80 Charlotte Street & 65 Whitfield Street:

Minor Material Amendment – Supplementary Design Report

Date
December 2015

Scope of additional demolition in red

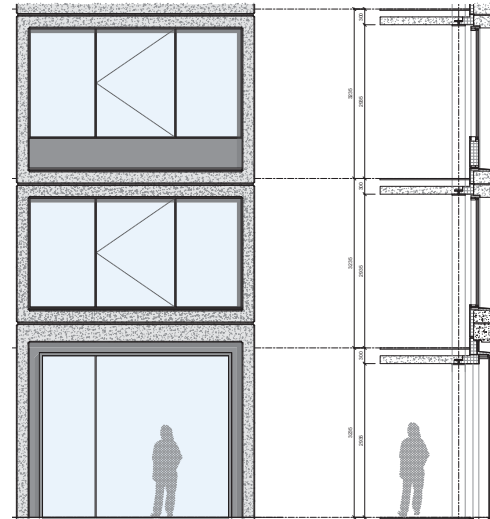
Design review 1 - 22nd September 2015

Street elevation studies: consented

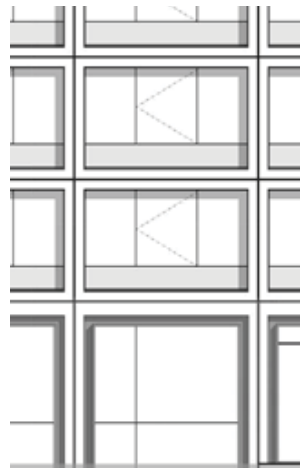
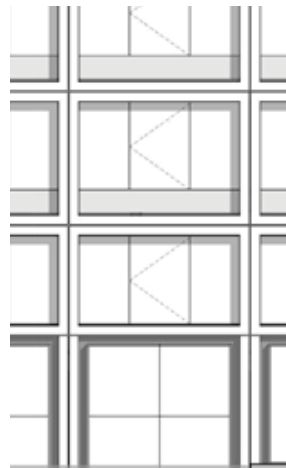
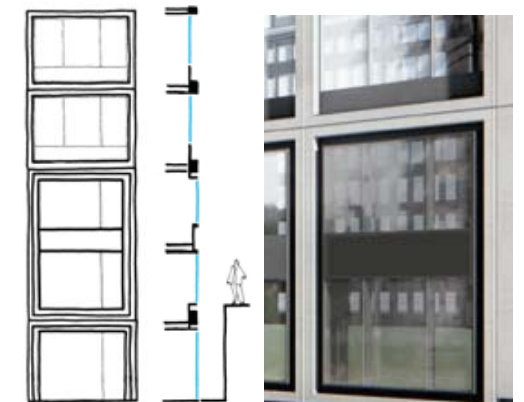
Design review 2 - 5th November 2015

Due to the lowered ground floor the ground floor street elevation appears reduced, studies to raise the frames to the spandrel of first floor

study: double height frame

Double height expressed cladding with metal spandrel panel

Model of brick weave elevation at pocket park note metal spandrel at first floor

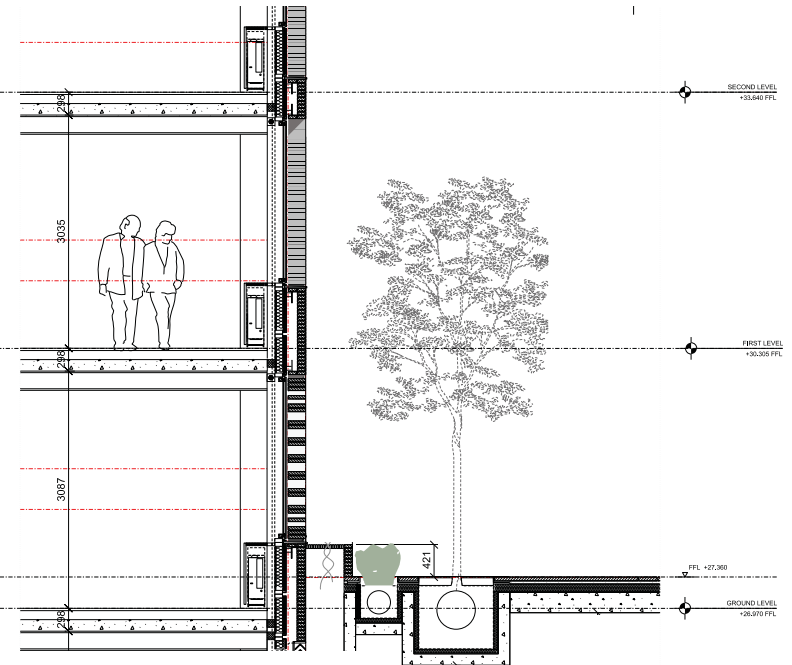
For 10-15 Chitty Street, at the rear of the pocket park officers were keen to ensure that the perception of the park was public and therefore queried potential office windows at a lower level. It was therefore discussed and agreed that a storey height lattice brickwork should be introduced, with the office windows behind, to limit views into the park. This will create an impression of solidity to the back of the pocket park, especially when viewed obliquely. The other advantages is at night, when the latticework will gently glow with light. The design also allows the office occupants to open the windows behind the lattice brick screen for natural ventilation, improving sustainable credentials. The proposal is similar to the approved lattice brick parapet to the retained façade, and is therefore in keeping with the architectural language of the approved scheme.

Brick weave introduced to Chitty street elevation at pocket park

Section and elevation of facade at pocket park note as agreed at the meeting the brick extends to window cill height of first floor
